GEORGETOWN-SCOTT COUNTY PLANNING COMMISSION

AGENDA

March 12, 2026

Staff Report to the Georgetown-Scott County Planning Commission

MASTER PLAN
GAINES FARM PROPERTY
 1367 PAYNES DEPOT ROAD
 LEXINGTON, FAYETTE COUNTY, KENTUCKY

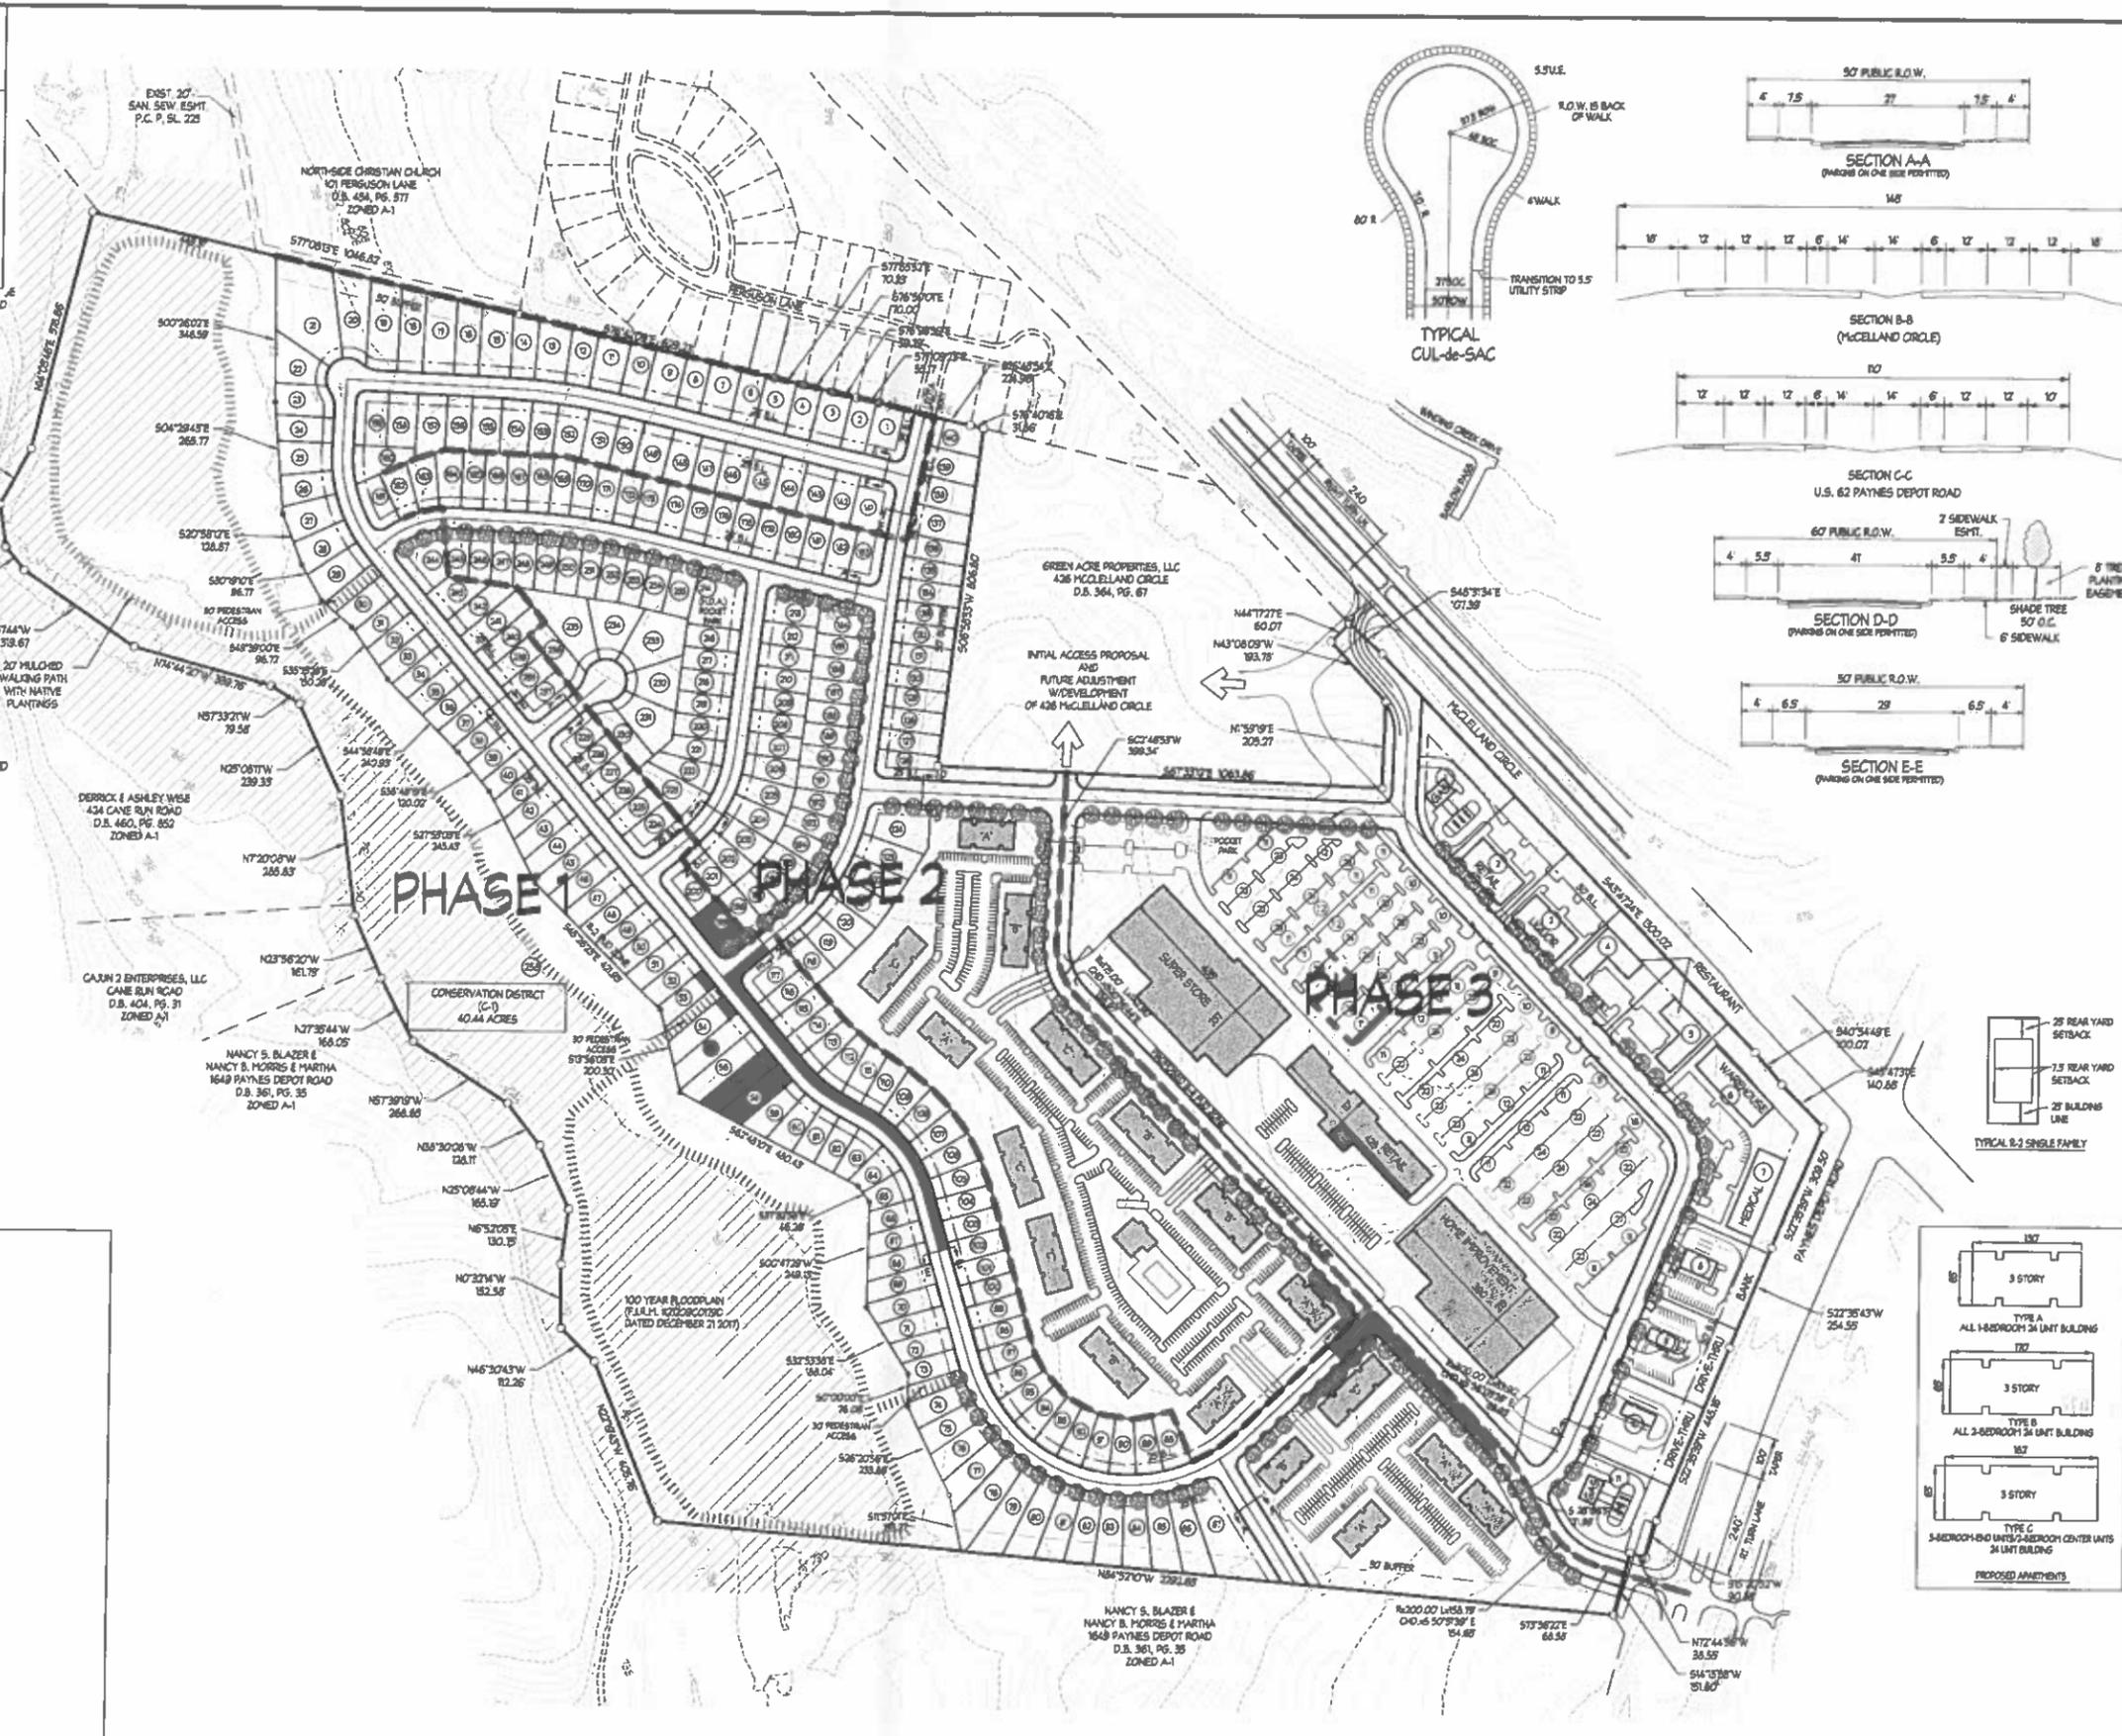
It was noted that alignment and cross sections of major access locations may require additional review for appropriateness and design. The access from McClelland Circle has been identified as needing additional review as the geometry of the roadway does not satisfy the requirements of the *Subdivision & Development Regulations*. Furthermore, notes regarding access to McClelland per additional linework and note what is being proposed regarding timing and coordination with the adjoining property owner to allow for acceptable tangent are also required. The Paynes Depot access should provide sufficient tangent and standard intersection to allow for adjoining stub street connection to the property to the south. The geometry of the road does not meet design requirements and will need to be rectified as part of the civil engineering plan and final subdivision plat.

Staff advises that the previously approved Condition of Approval #9 be maintained if the preliminary subdivision plat and area master plan are approved. The Condition of Approval states that the development area shall have two connections to off-site public roads and that new roadway construction shall not originate from the terminus of Leota Way, an existing public road serving the McClelland View neighborhood. The intent of this condition is to ensure that no one roadway absorbs traffic greater than what it is rated for, as Leota Way is not constructed to the "Collector Road" standard set forth by the *Subdivision & Development Regulations*, while Paynes Depot Road and McClelland Circle are constructed to that standard. Furthermore, the condition of approval is intended to ensure that the existing neighborhood is not subject to the heavy machinery traffic associated with new roadway construction.

① BUILDING SECTION - NS
1/16" = 1'-0"

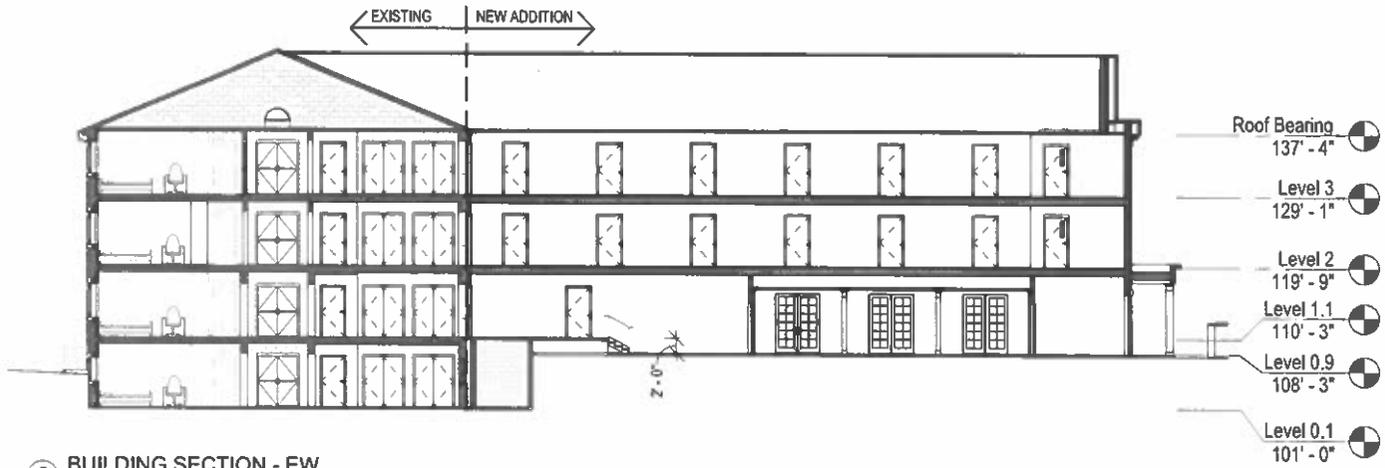
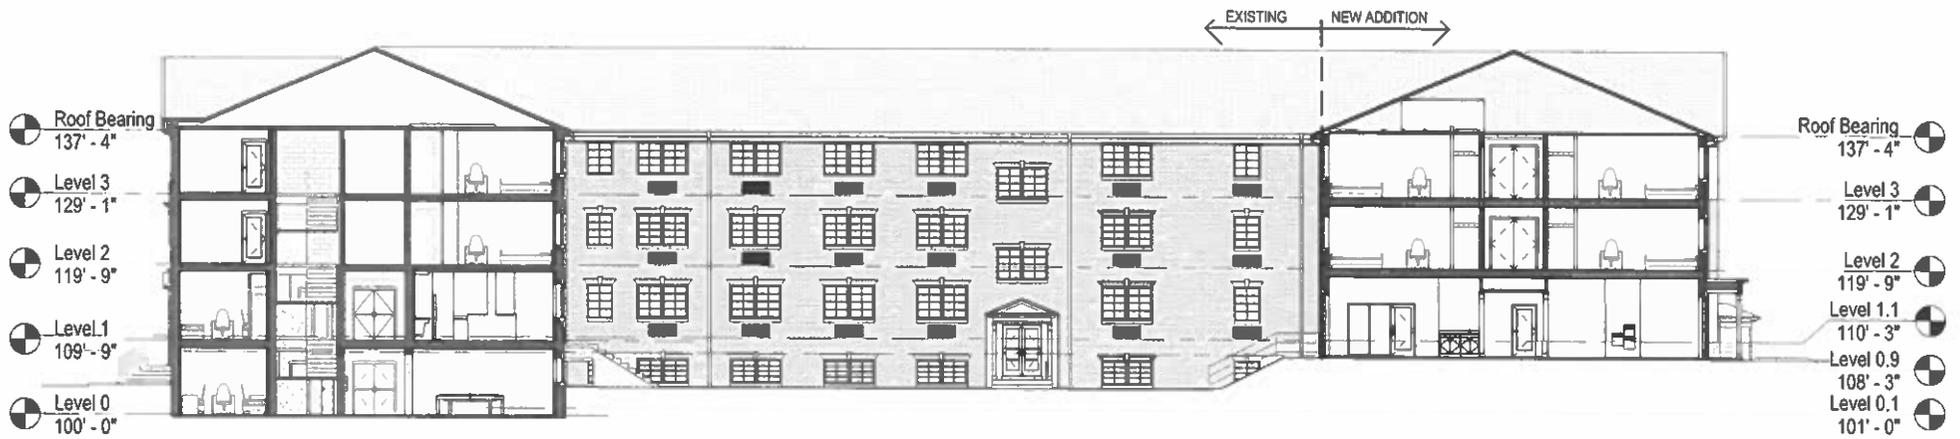
Variance Request 1: The applicant requests an 18-foot, 3-inch variance from the height restriction of two stories or 30 feet in the R-2 zoning district, citing that the plan is for the addition to match the existing height and style providing uniformity to the building and that unnaturally lowering the building below this requirement would look odd in the neighborhood. A matching of the proposed addition in height and style to the existing structure will provide uniformity to the building, and that unnaturally lowering the building below this requirement would look odd in the neighborhood.

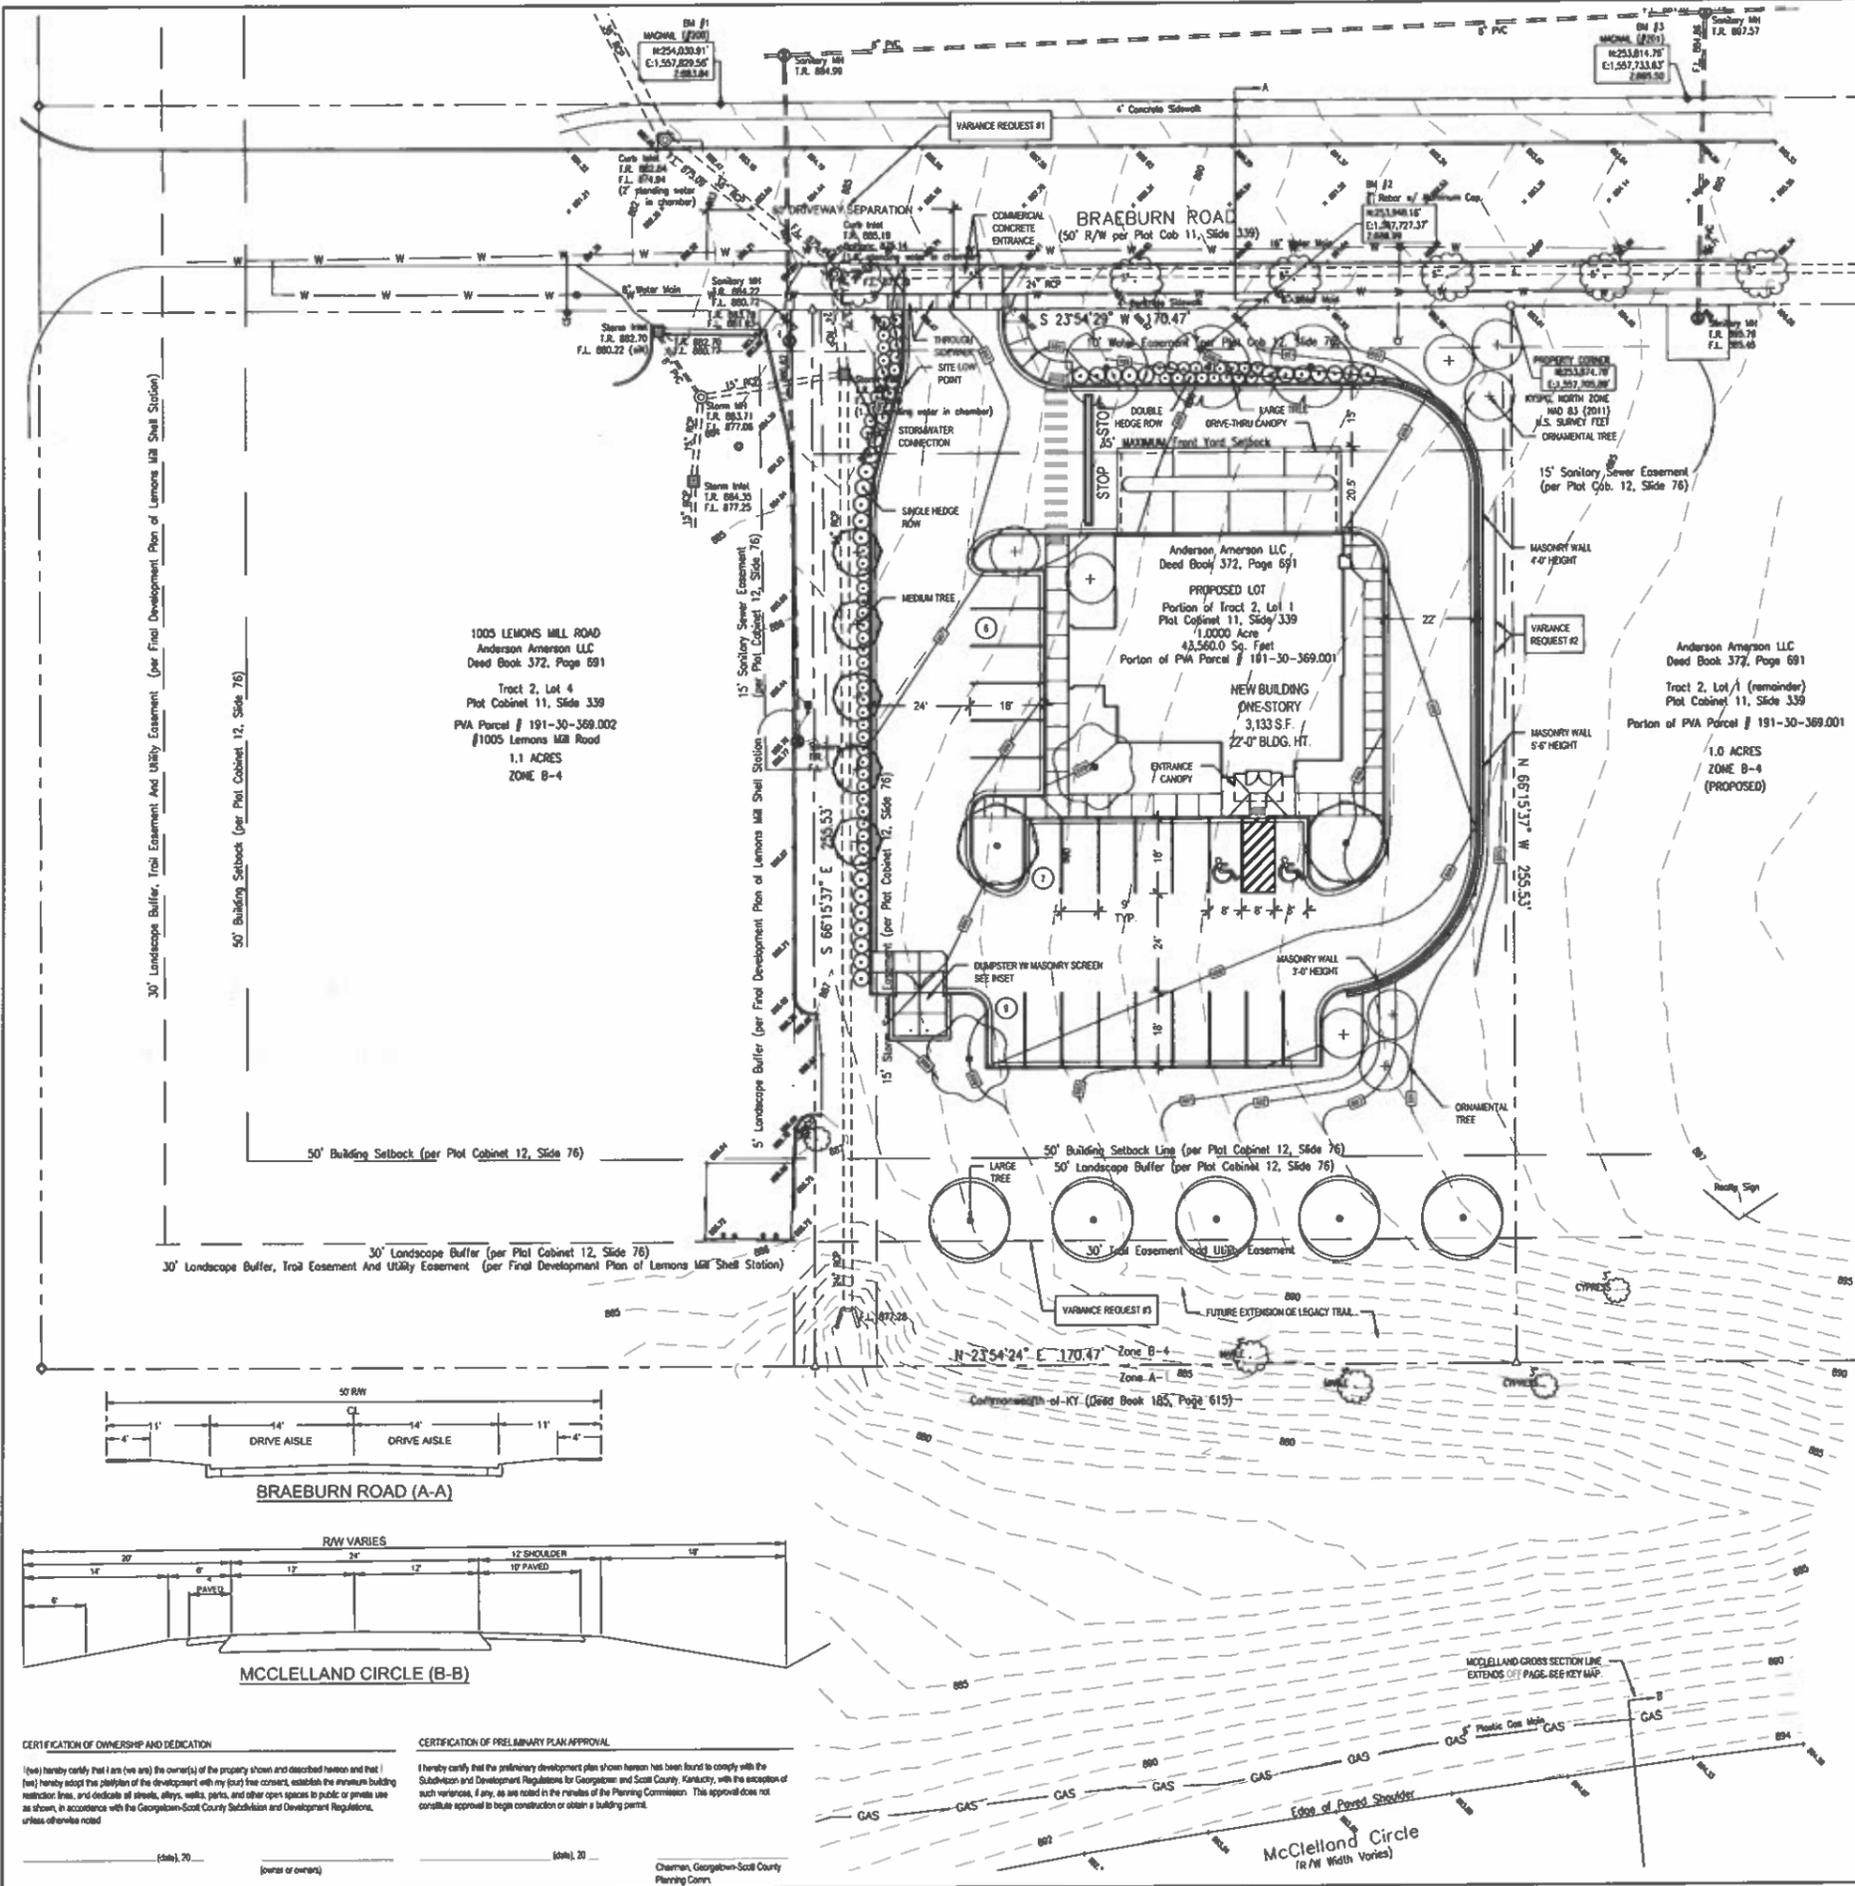
- 1. A 40-foot reduction of the minimum required distance between driveways (100 foot minimum) (X.1000.Q.2 of the *Subdivision and Development Regulations*).
- 2. Waiving the requirement of 1 tree per 40 feet of linear boundary to the south portion of vehicular use area (section 6.13.1 of the *Landscape and Land Use Buffer Ordinance*).
- 3. Waive the requirement of a 6-foot-tall no-climb boundary fence when adjoining the A-1 (6.14 of the *Landscape and Land Use Buffer Ordinance*).
